Marin County Flood Control and Water
Conservation District
**Corte Madera Creek Flood Risk Management
Project, Phase 1**
Final Environmental Impact Report
Volume 1: Comments and Responses to Comments
State Clearinghouse No. 2020080353

**Marin County Flood Control and Water
Conservation District
Corte Madera Creek Flood Risk Management
Project, Phase 1
Final Environmental Impact Report
Volume 1: Comments and Responses to Comments
State Clearinghouse No. 2020080353**

Figure 2-3 Alternative 1 Change in Water Surface Elevation from Existing Conditions, 25-Year Flood Event (Upper Corte Madera Creek)

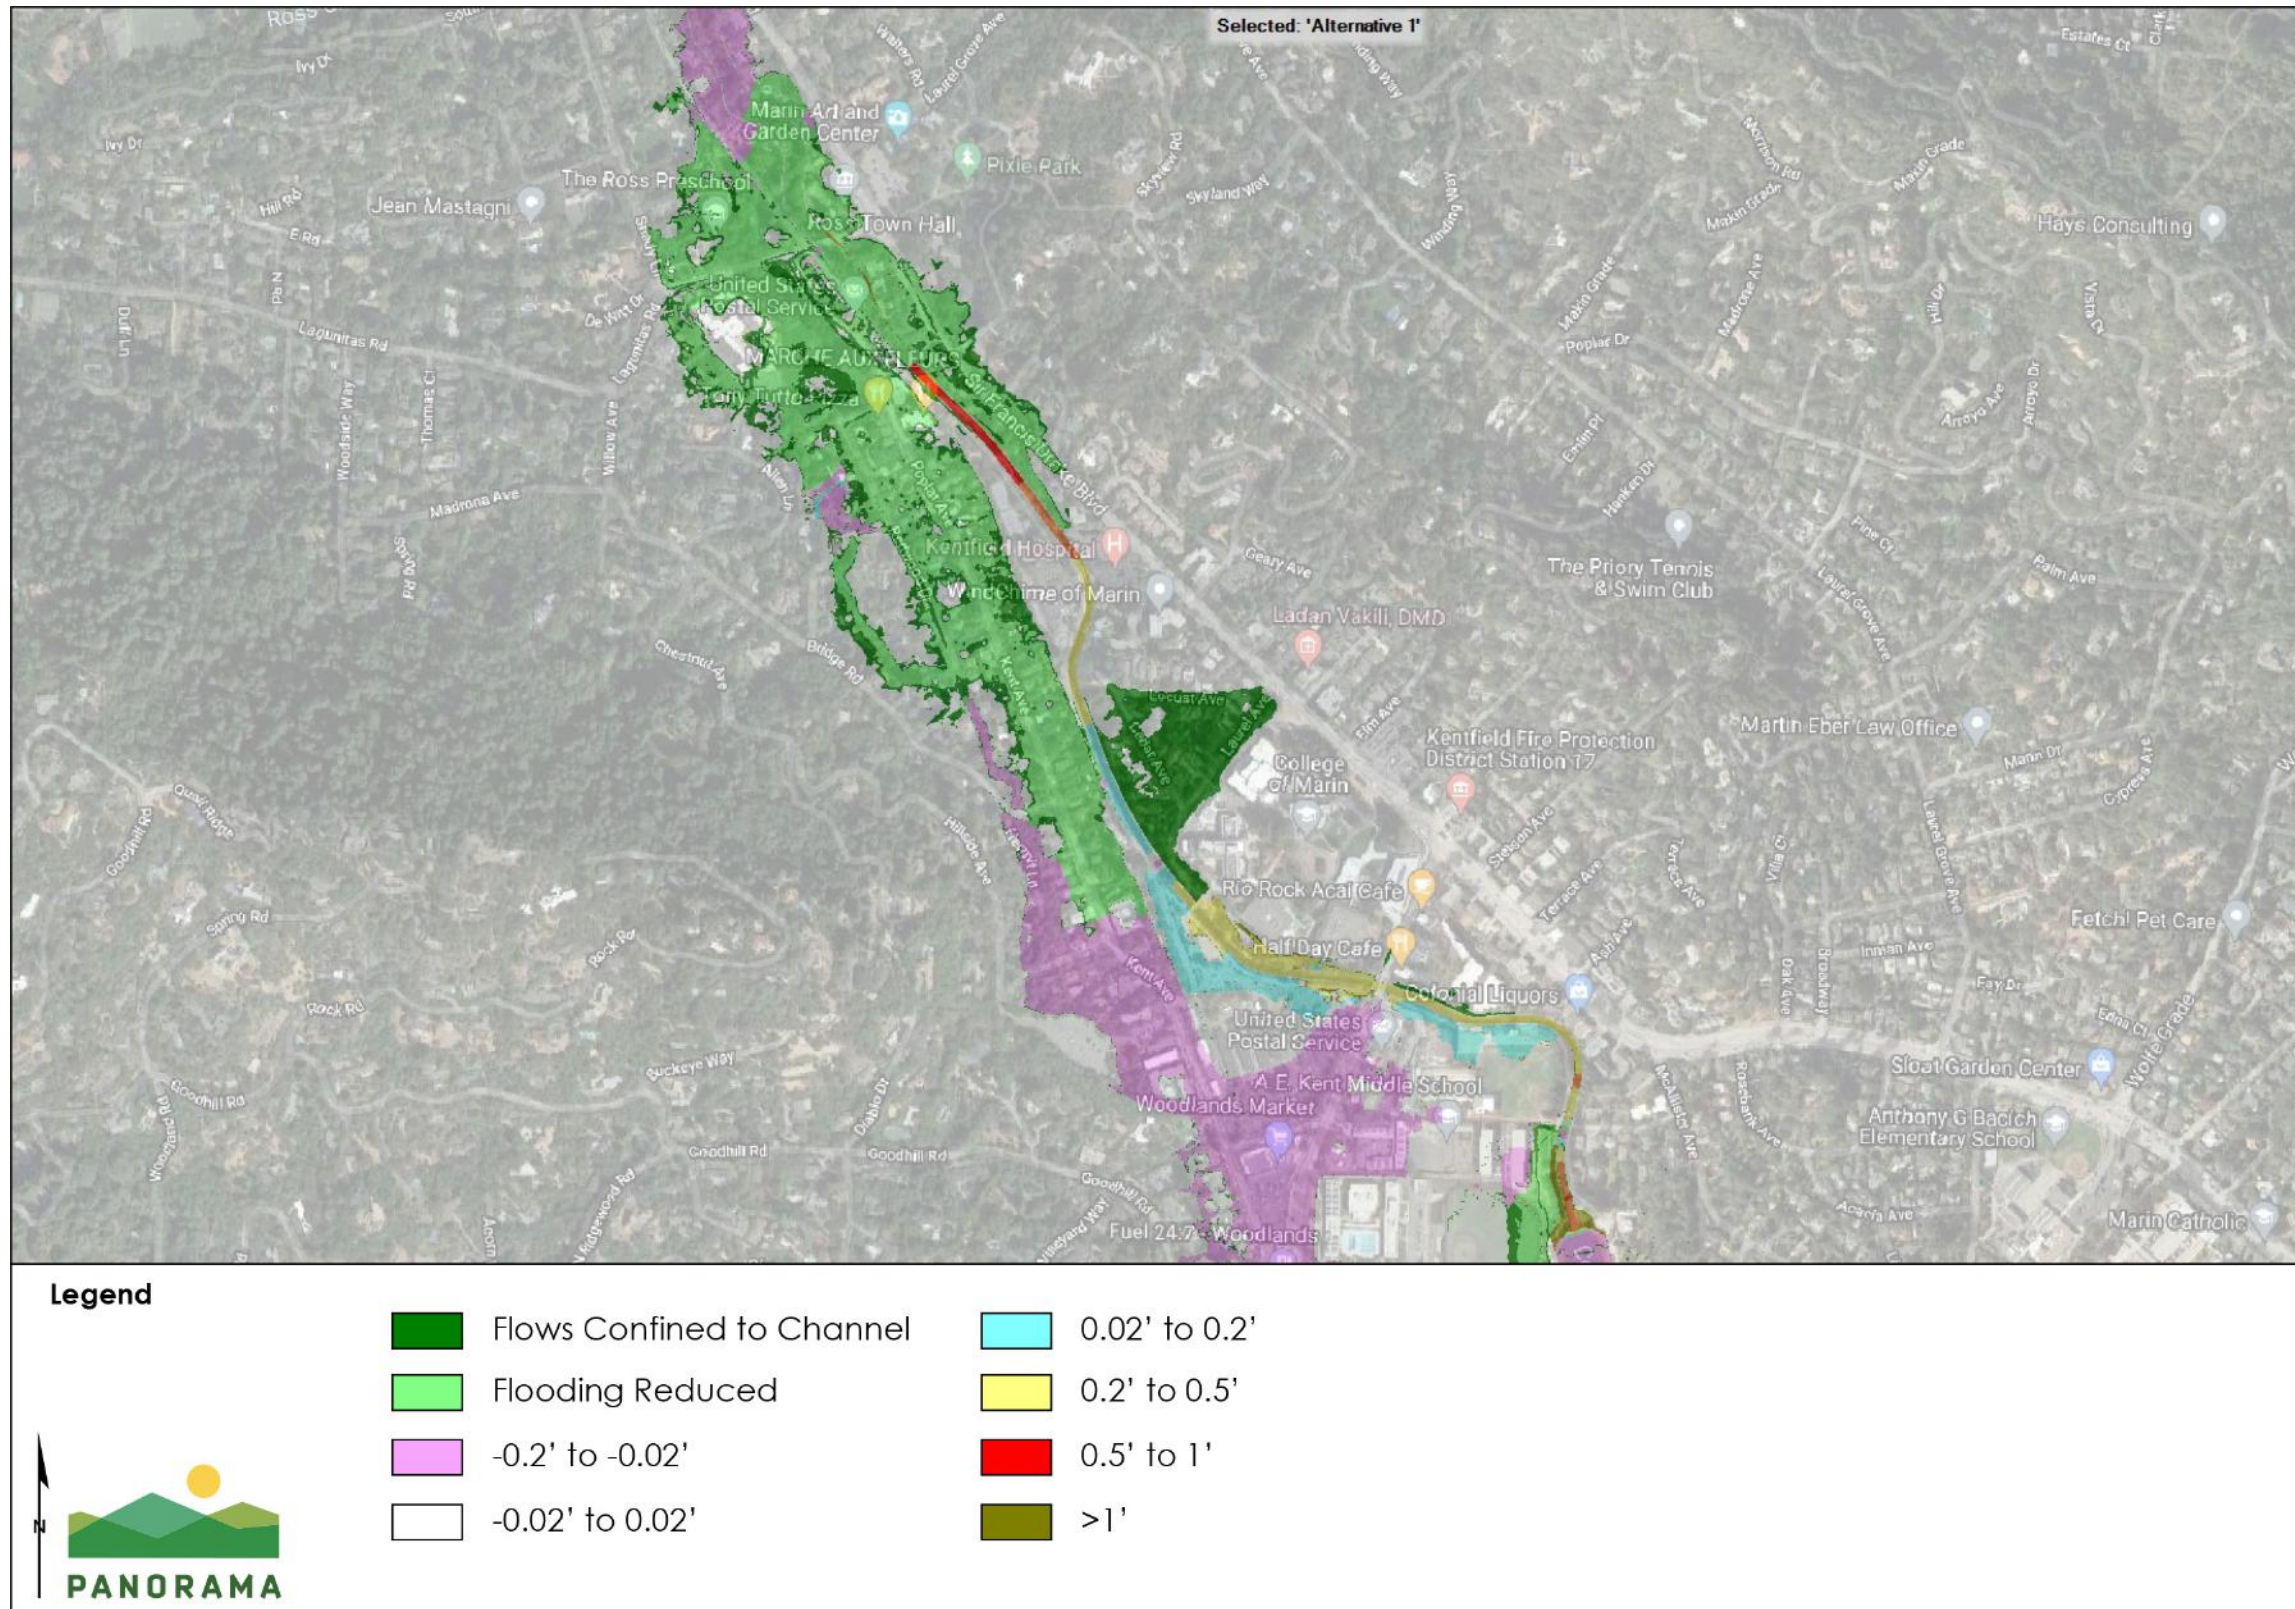
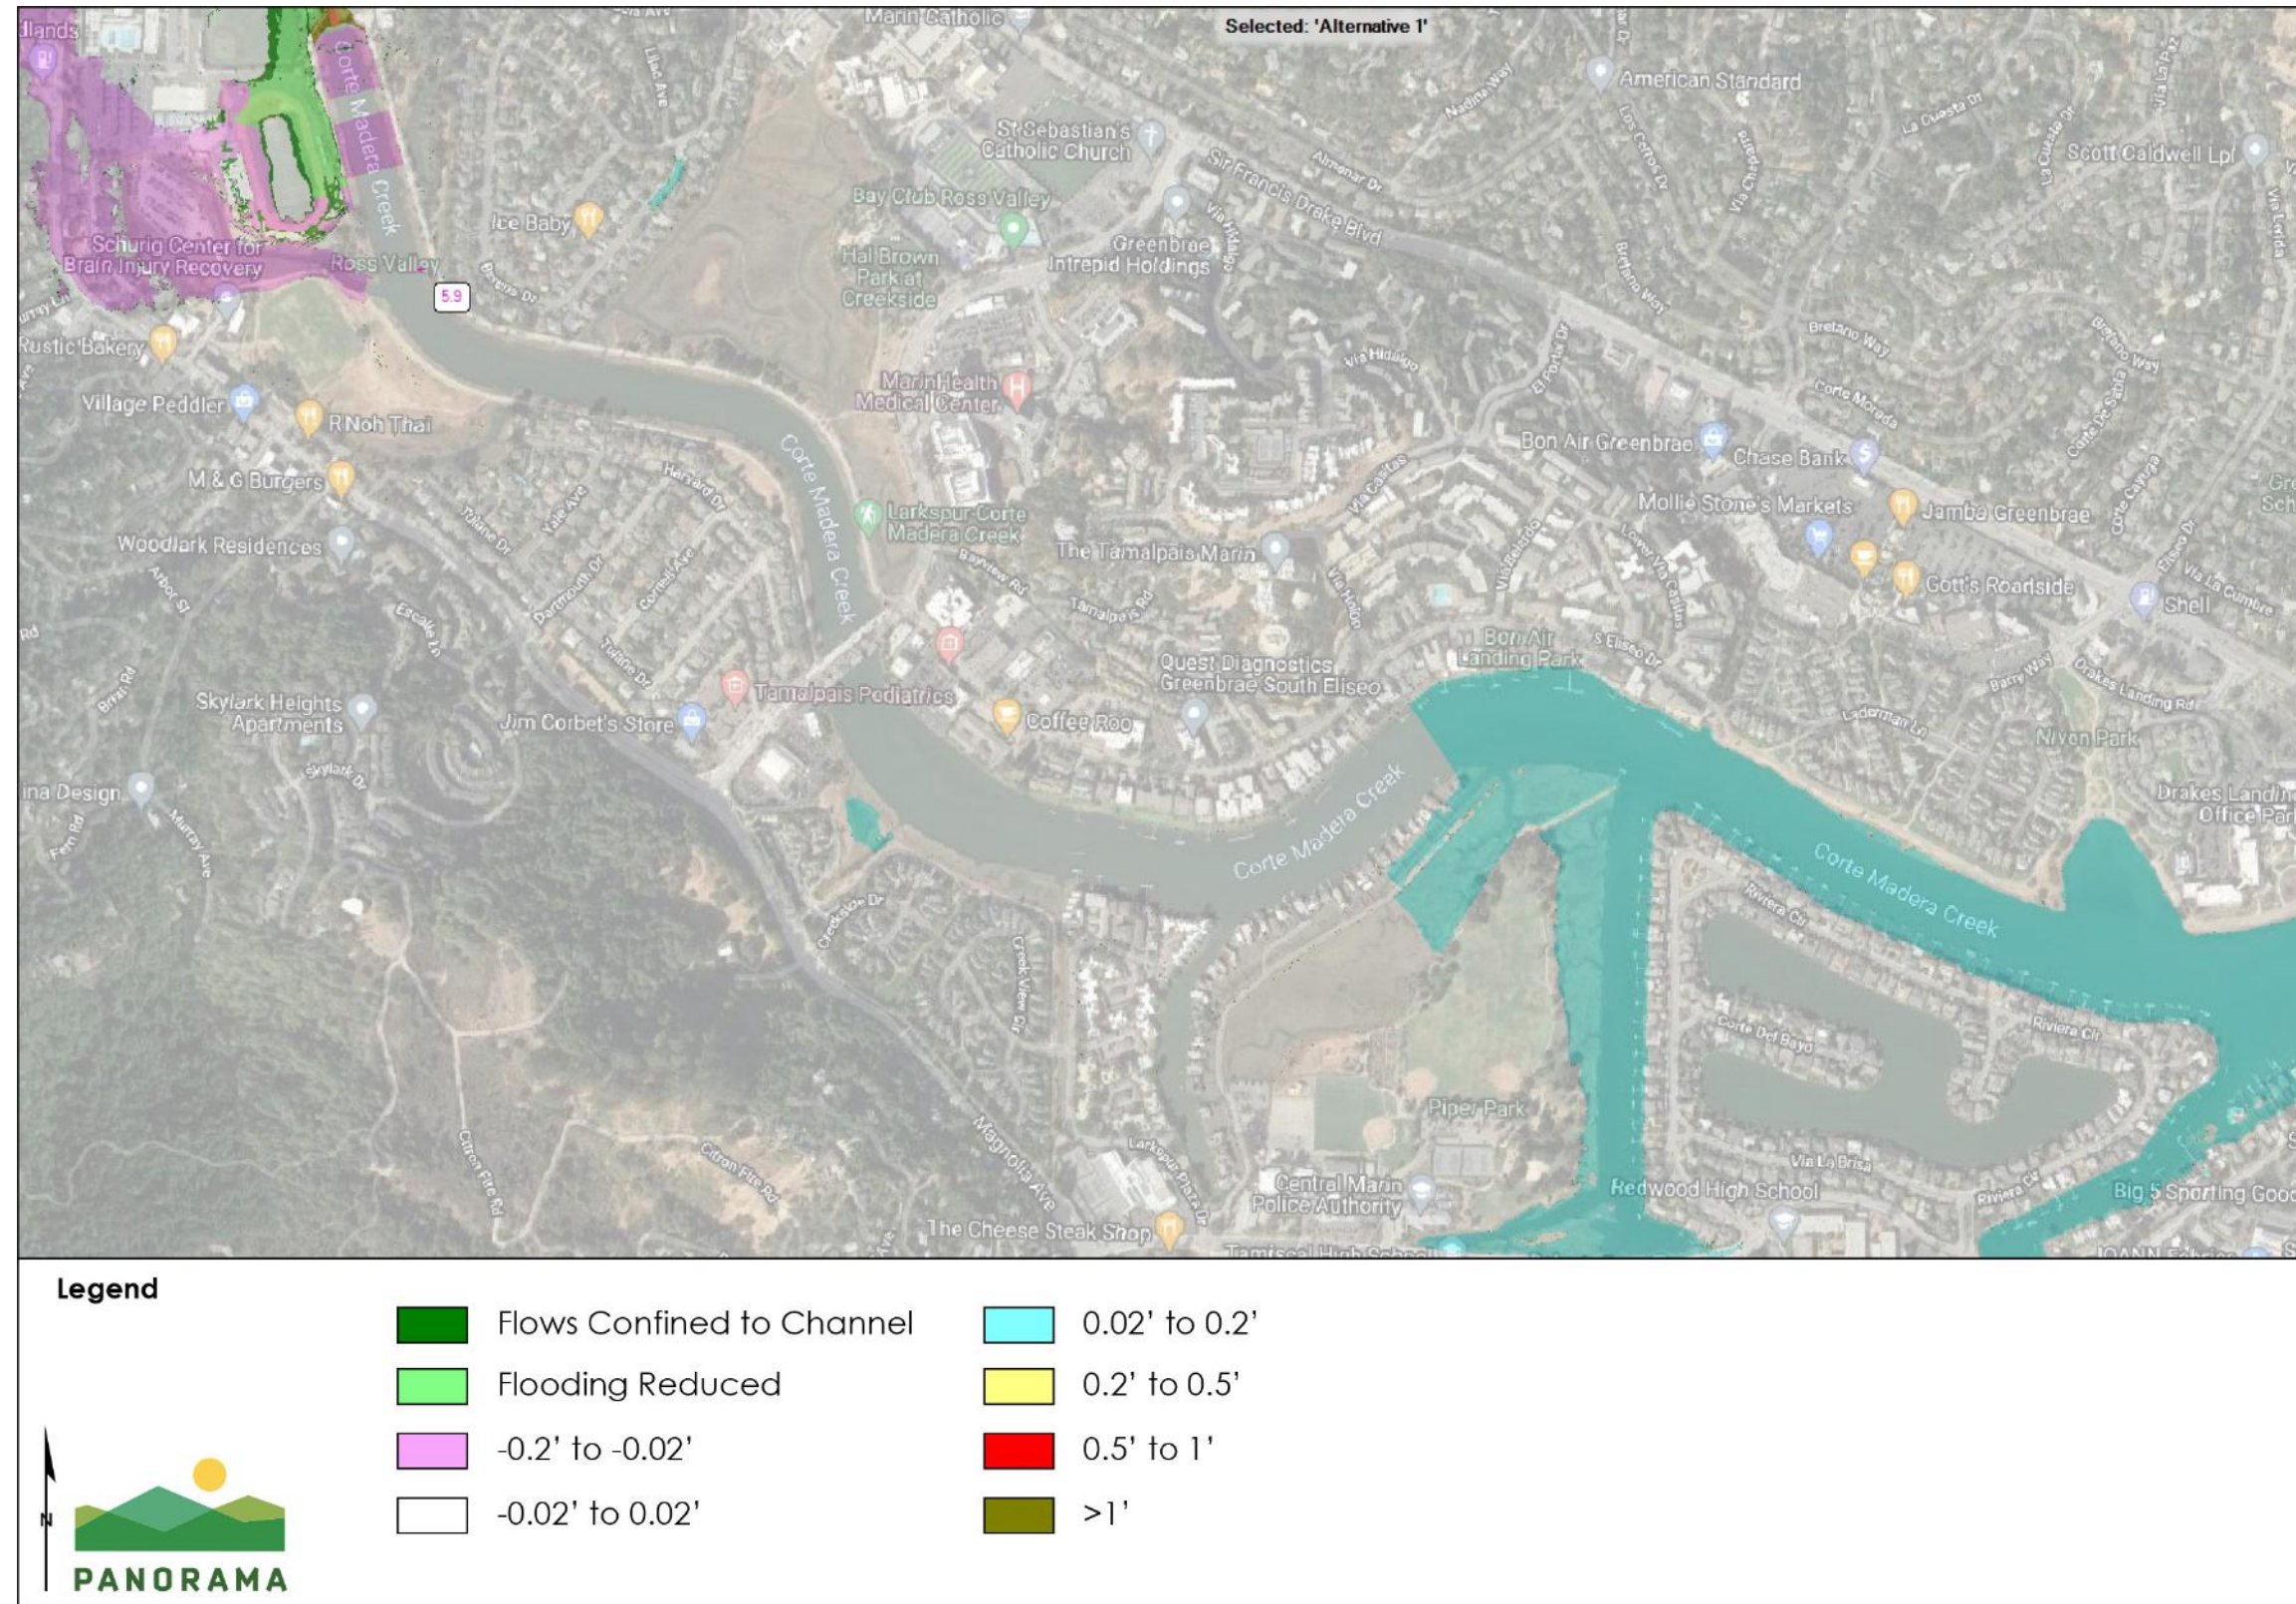
The geographic extent of the figures showing the changes in WSE differs from the figures included in the Draft EIR. The geographic extent of the figures was expanded to show areas downstream from Unit 2 in response to comments from the City of Larkspur. As discussed on page 3.9-39 in the Draft EIR, a threshold of 0.2 foot (2.4 inches) was used for determining whether a potentially significant increase or decrease in WSE would occur at any structure. The 0.2-foot threshold is a reasonable level of precision for evaluating flooding impacts, considering the standards for accuracy and precision associated with hydraulic modeling.

Figure 2-1 through Figure 2-6 show the Alternative 1 changes to the WSE and reflect the difference in WSE between the Existing Condition Without Project and Existing Condition With Alternative 1 scenarios under a 10-, 25-, and 100-year flood, using the updated modeling for the 60 percent design. Figure 2-7 through Figure 2-12 show the Alternative 1 changes to the WSE under for the future condition scenario, and reflect the difference in WSE between the Future Condition Without Project and Future Condition With Alternative 1 under the 10-, 25-, and 100-year flood conditions. The assumptions used in the future condition modeling are described on pages 3.9-35 through 3.9-37 in Section 3.9 in the Draft EIR and are supplemented by the model updates described above. Figure 2-13 through Figure 2-18 show the Alternative 1 changes to the WSE under a “high-emissions likely” sea-level rise scenario, to reflect 2100 projected sea-level rise based on the 2018 Update of the State of California Sea-Level Rise Guidance (California Ocean Protection Council, 2018). Figures 2-13 through 2-18 reflect the difference in WSE between the Year 2100 Future Condition Without Project and Year 2100 Future Condition with Alternative 1 scenarios under the 10-,25-, and 100-year flood conditions.

Areas shown in the figures as “Flows Confined to Channel” are areas that are currently flooded by Corte Madera Creek, which are predicted to no longer have flood inundation from Corte Madera Creek overtopping after Alternative 1 is implemented. Areas shown in the figures with “Flooding Reduced” are areas with reduced flood inundation (greater than 0.2 foot) from creek overtopping after Alternative 1 is implemented. The change in WSE shown on the maps reflects a comparison between WSE without implementation of Alternative 1 and the WSE after implementation of Alternative 1 for each modeled scenario.
